<b>SUNDRY NOTICES AND REPORTS ON WELLS</b> (DO NOT USE THIS FORM FOR PROPOSALS TO DRILL OR TO DEEPEN OR PLUG BACK TO A DIFFERENT RESERVOIR. USE "APPLICATION FOR PERMIT" (FORM C-101) FOR SUCH PROPOSALS.)		WELL API NO. 30-025-42207

NOTICE OF INTENTION TO:		SUBSEQUENT REPORT OF:	
PERFORM REMEDIAL WORK <input type="checkbox"/>	PLUG AND ABANDON <input type="checkbox"/>	REMEDIAL WORK <input type="checkbox"/>	ALTERING CASING <input type="checkbox"/>
TEMPORARILY ABANDON <input type="checkbox"/>	CHANGE PLANS <input type="checkbox"/>	COMMENCE DRILLING OPNS. <input type="checkbox"/>	P AND A <input type="checkbox"/>
PULL OR ALTER CASING <input type="checkbox"/>	MULTIPLE COMPL <input type="checkbox"/>	CASING/CEMENT JOB <input type="checkbox"/>	
DOWNHOLE COMMINGLE <input type="checkbox"/>			
CLOSED-LOOP SYSTEM <input type="checkbox"/>			
OTHER: REVISION TO 10M BOP System <input checked="" type="checkbox"/>		OTHER: <input type="checkbox"/>

DCP Midstream LP respectfully requests a revision to the 10M BOP/BOPE system for the 8-3/4" hole from a:

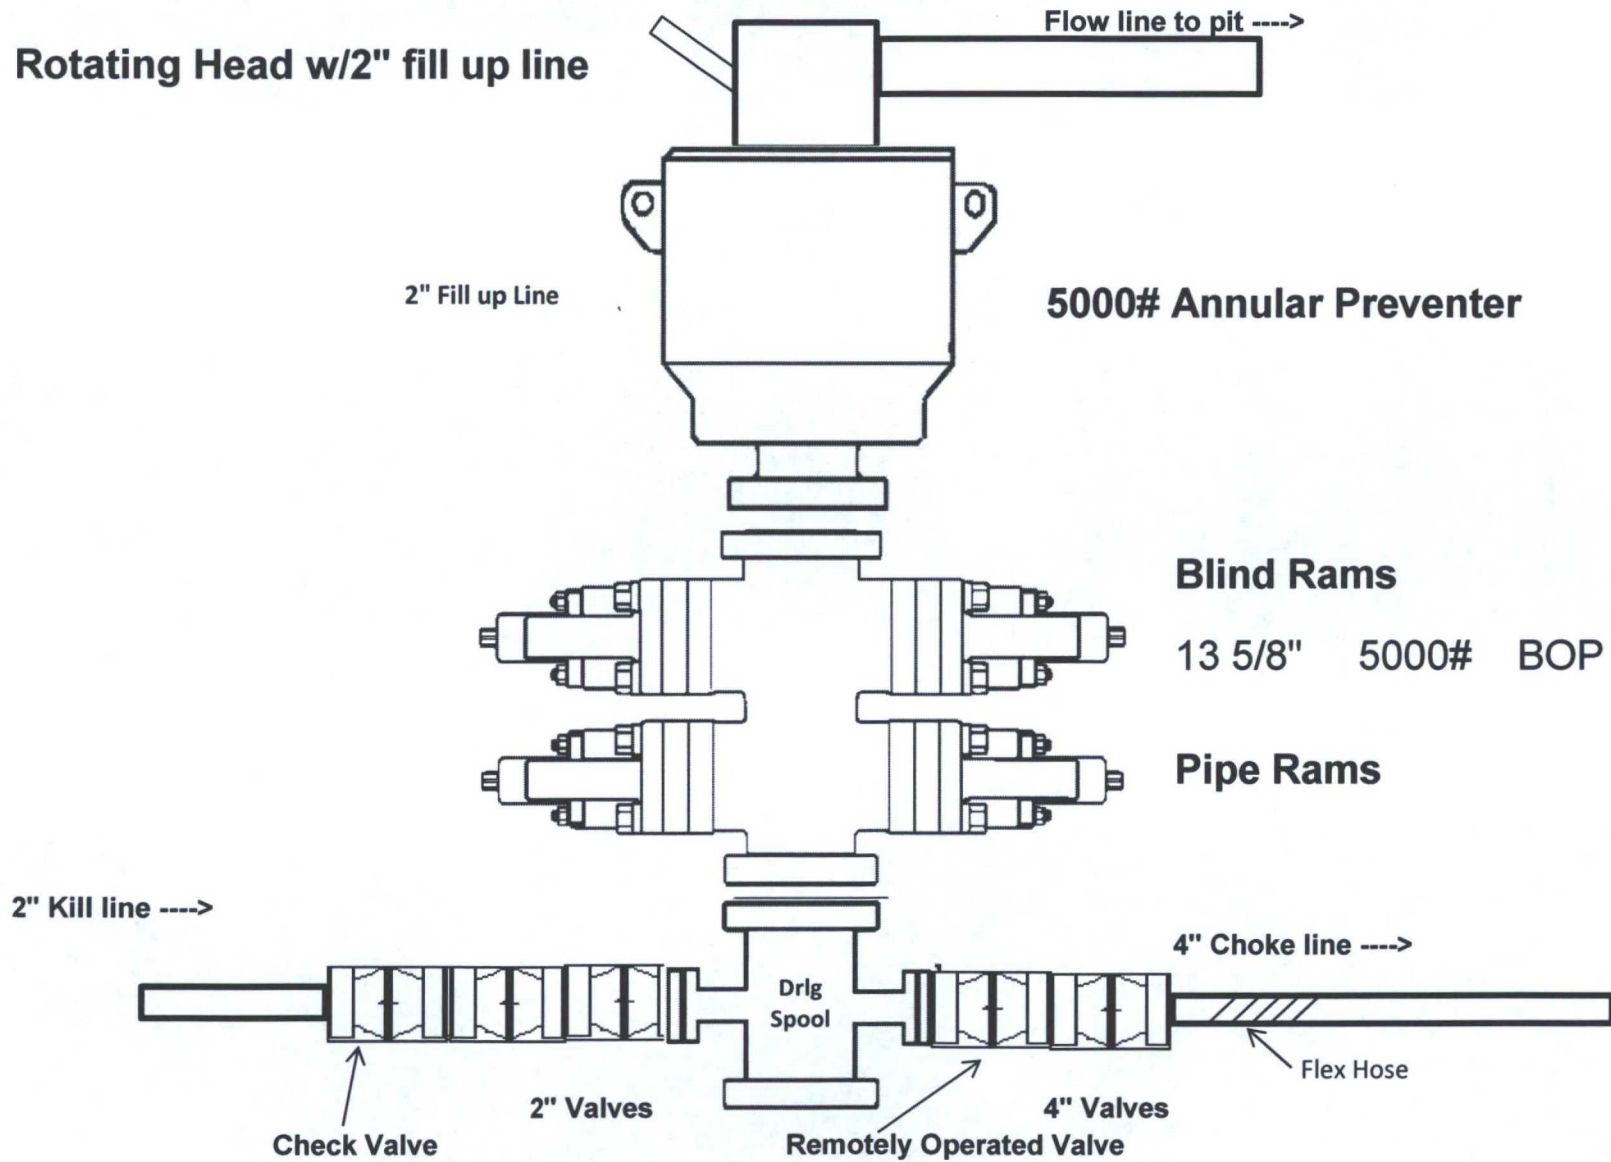
10M BOP system with a 3 Choke manifold system to a:

5M BOP system with a 2 Choke manifold system.

Please see attached for schematics of the 5M BOP and Choke manifold equipment system. The MASP will be approximately 4,840 psi with a half evacuated hole at the anticipated mud weights. It was agreed that the 5M BOP and Choke system will be sufficient for the entire 8-3/4" hole.
